6436 W. Hollywood Blvd  
DOT Case No. CEN 16-44677

Subject: **TRANSPORTATION IMPACT ASSESSMENT FOR THE PROPOSED  
MIXED-USE DEVELOPMENT PROJECT LOCATED AT 6436 WEST  
HOLLYWOOD BOULEVARD**

FIGURE  
1

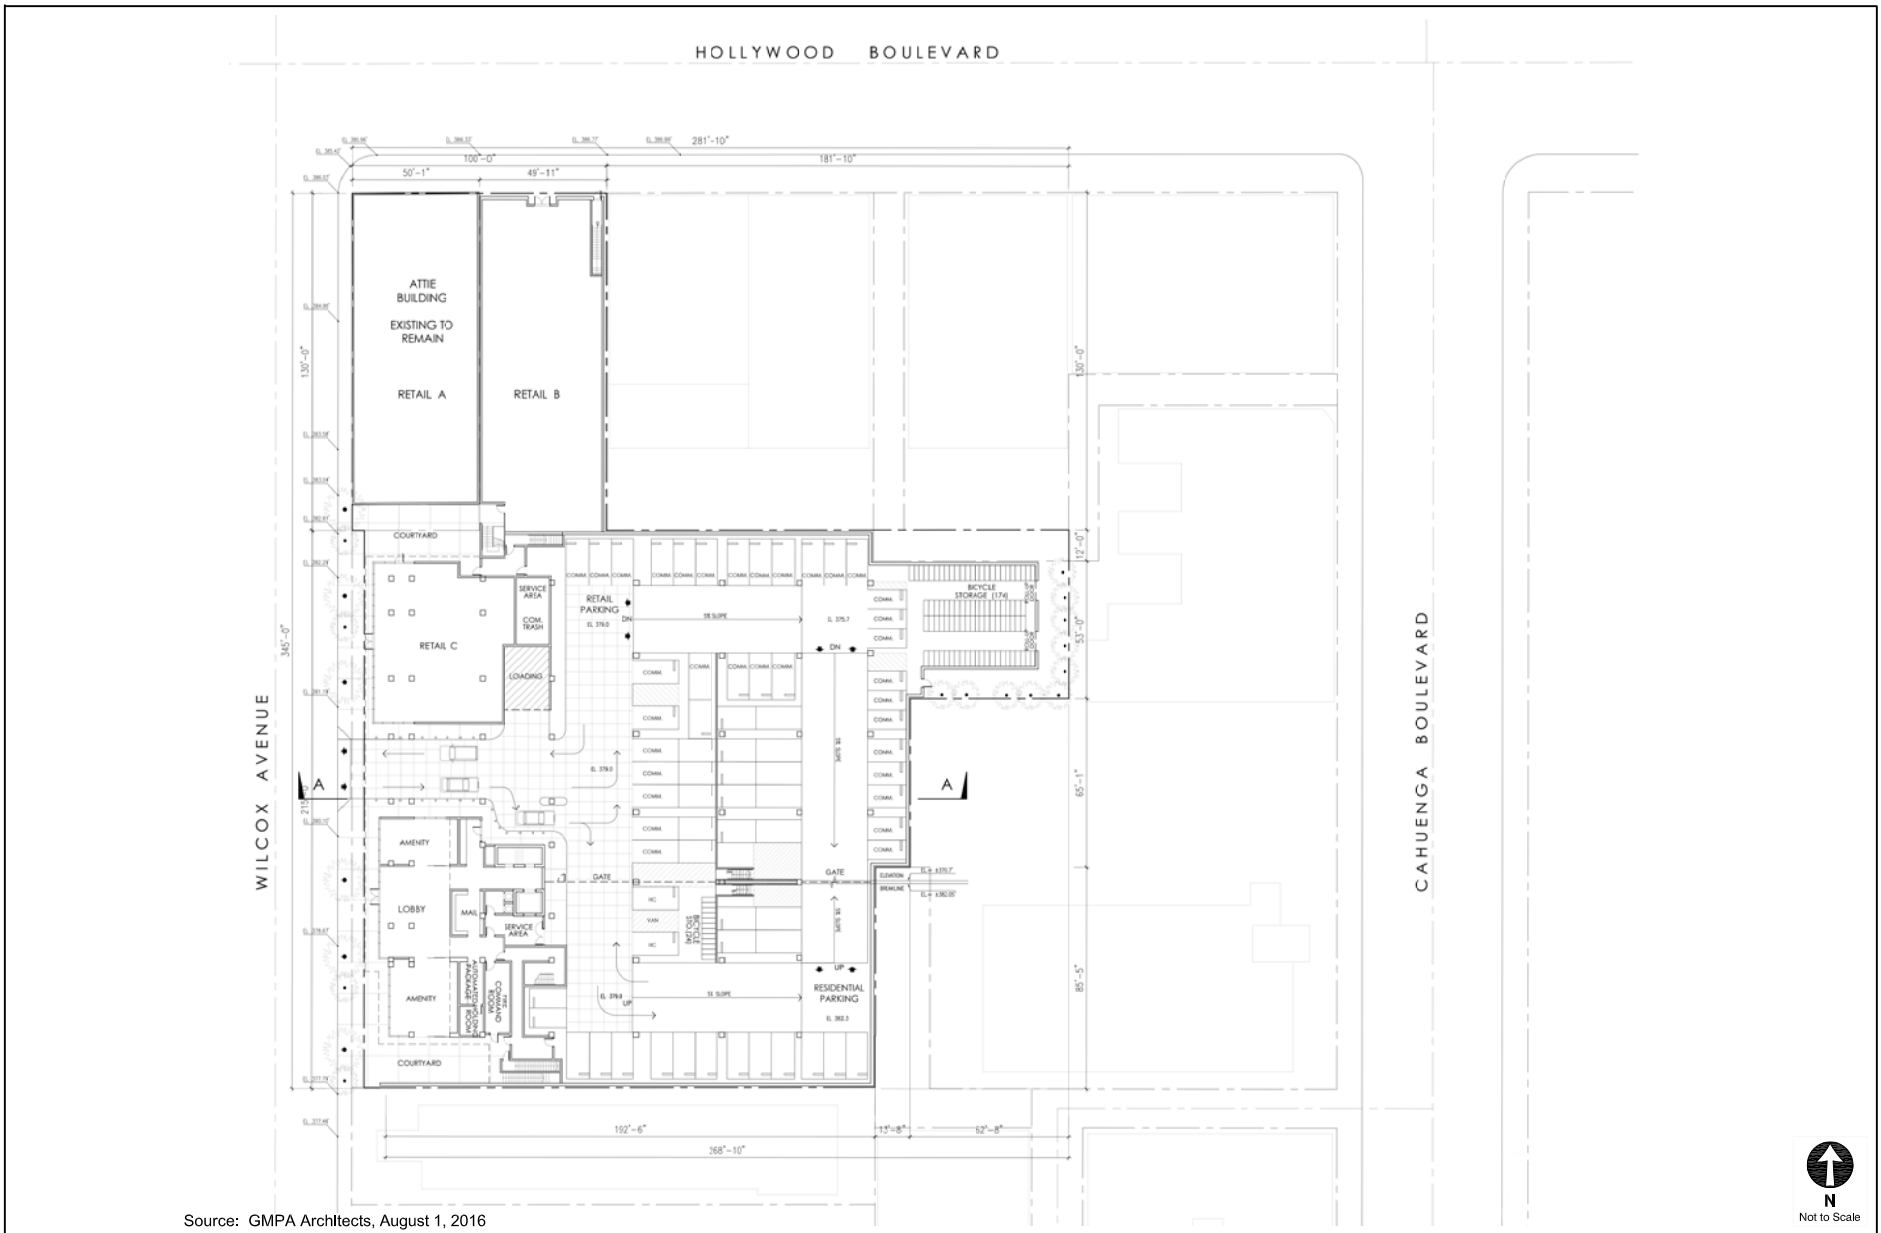
The proposed site plan illustrated in **Attachment 4** is acceptable to DOT; however, review of the study does not constitute approval of internal circulation schemes and driveway dimensions. Those require separate review and approval and should be coordinated with DOT's Citywide Planning Coordination Section (201 N. Figueroa Street, 5th Floor, Station 3, @ 213-482-7024). In order to minimize and prevent last minute building design changes, the applicant should contact DOT, prior to the commencement of building or parking layout design efforts, for driveway width and internal circulation requirements. Any changes to the project's site access, circulation scheme, or loading/unloading area after issuance of this report would require separate review and approval and should be coordinated as well.
